Memorandum

Project SVM

Docket 70-36

Subject: Mallinckrodt Chemical Works

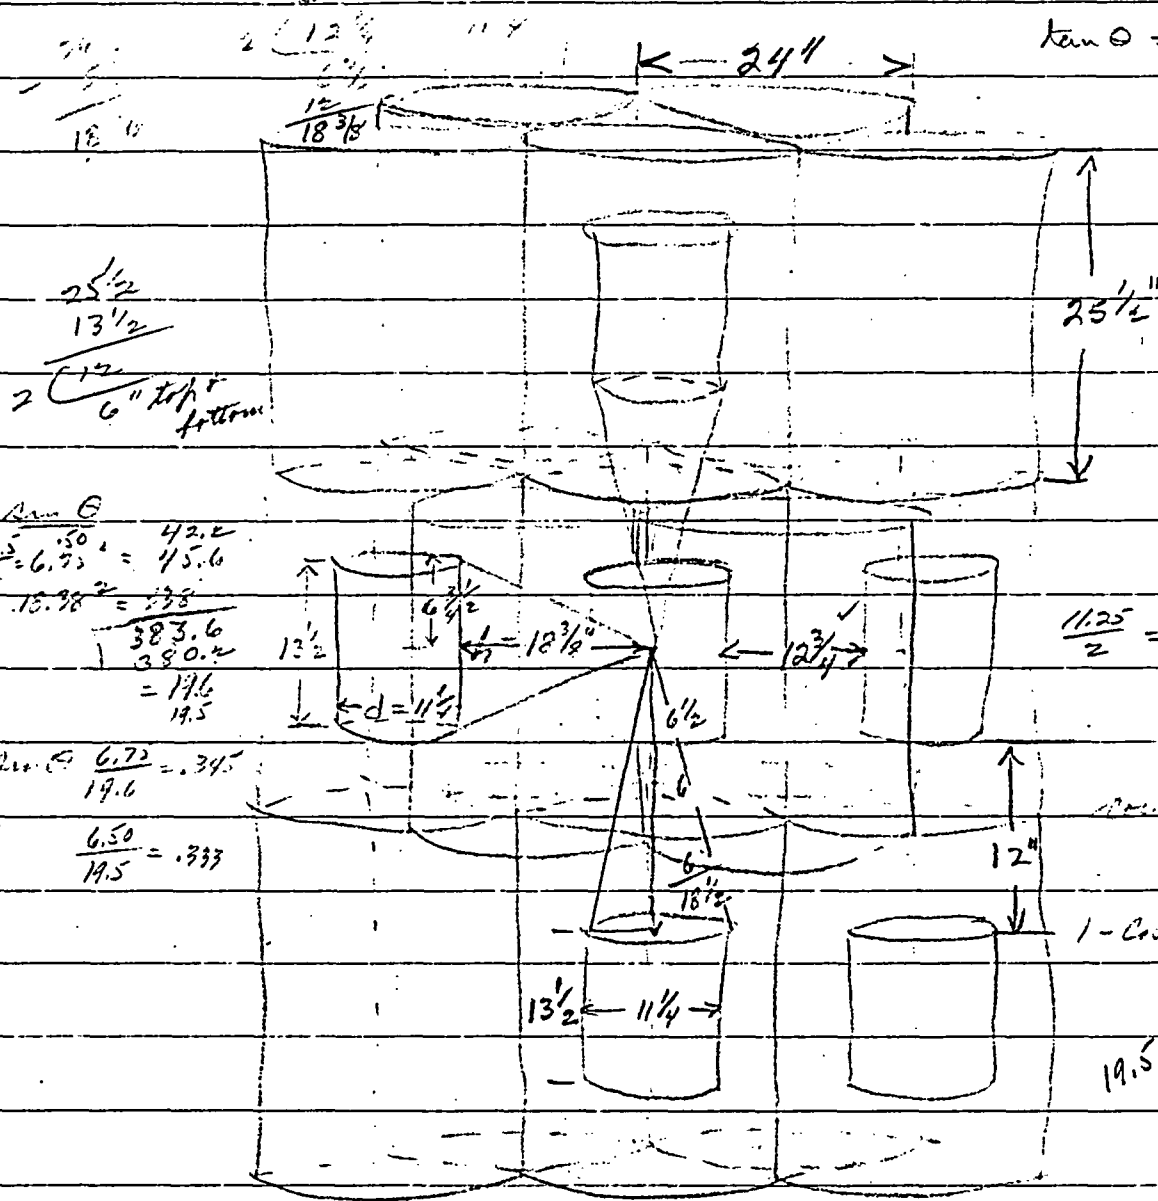
General:  $\frac{\text{Cross sect area}}{\text{Sep. Dist}^2} = \frac{11.25 \times 13.50}{18.37^2} = 0.45$  for one drum

for 6 drums,  $\eta = 6 \times 0.45 = 2.70$

vs. 2.45

End to End  $\frac{.785(11.25)^2}{18.5^2} = .29$

2 drums  $\eta = 2 \times .29 = 0.58$  vs 0.55

For 6 coplanar drums  $\eta = 6 \left[ 2 \frac{d''}{12} \frac{1}{h'} \sin \theta \right] = 12 \frac{11.25}{18.38} (.333)$   
Using relation  $\frac{\text{Cross Sect. Area}}{(\text{Sep. Dist})^2} = \frac{13.5 \times 11.25}{(18.38)^2} = 0.45$   
 $6 \times 0.45 = 2.70$

for drums above and below  $\eta = 2 \left[ 2\pi (1 - \cos \theta) \right] = 2(6.29)(1 - .956)$   
 $\frac{.785(11.25)^2}{(18.5)^2} = .29$   
 $.29 \times 2 = .58$

Total angle =  $2.45 + 0.55 = 3.00$

$\frac{3}{12\pi} = 23.9\%$  OK if  $k=0.58$  Single layer  $\rightarrow 2.45/4\pi = 19.5\%$  for  $k=0.65$   
Var 8% for  $k=0.8$
